RECONVENED MEETING OF ARGYLL AND BUTE LOCAL REVIEW BODY

3. CONSIDER NOTICE OF REVIEW: DRUMFORK HOUSE, DRUMFORK ROAD, HELENSBURGH G84 7TS

LOCAL REVIEW BODY REFERENCE: 11/004/LRB PLANNING APPLICATION REFERENCE: 10/01287/PP LOCATION: DRUMFORK HOUSE, DRUMFORK ROAD, HELENSBURGH.

TOWN AND COUNTRY PLANNING (SCOTLAND) ACT 1997 (AS AMENDED) PROPOSAL: Repositioning of gates and erection of boundary fence SITE ADDRESS: Drumfork House Drumfork Road Helensburgh Argyll And Bute G84 7TS

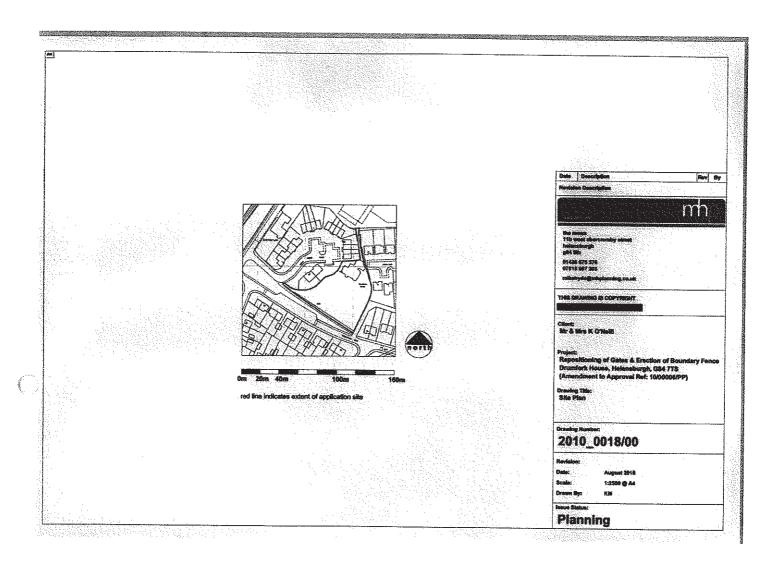
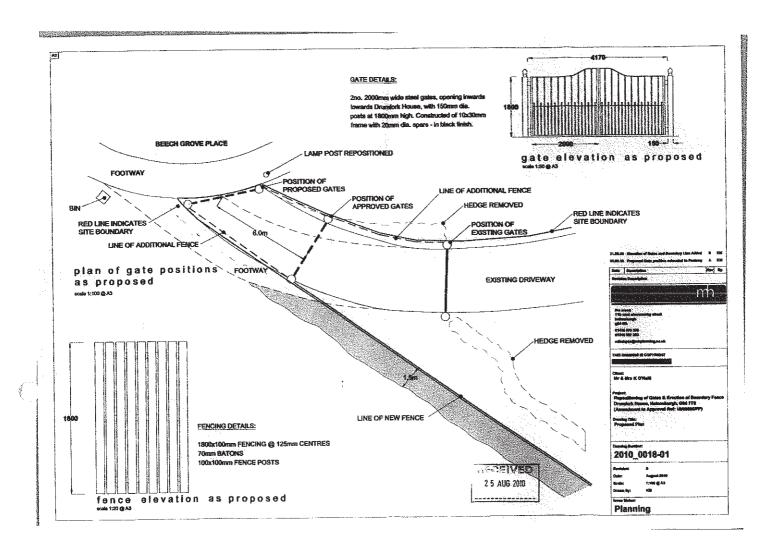
ltem Ref.	REFUSAL
	In the interest of Road and Pedestrian safety I would recommend refusal due to the following reasons.
	1. Pedestrian forward visibility sightlines on the footpath will be restricted.
	2. The existing surfaced public footpath will be reduced to an unacceptable width
	 The proposed driveway gates should be positioned a minimu 6 metres back fro the heel of the footway to ensure that there is no conflict between vehicles entering Drumkfork House and vehicles travelling in both directions at the corn within Beechgrove Place.

The proposal to re-locate the driveway access gates adjacent to the heel of the footway is not acceptable in the interest of road and pedestrian safety. This road is within a 30 mph speed limit with the location of the existing driveway on the outside of a 90 degree bend. Therefore in order to allow the driveway gates to be opened to allow vehicle entry into the property would create a hazard by obstructing the passage of other vehicles during this process. As previously intimated I would recommend that the gates are positioned a minimum distance of 6 metres behind the heel of footway.

The position of the fence and the realignment of the footpath will restrict pedestrian forward visibility and creates a less user friendly right of way. This footpath is used by a number of local parents and children taking access to the nearby primary school. A further benefit gained by locating the gates back 6 metres from the heel of the footway would mitigate the requirement to provide a new footway at this location.
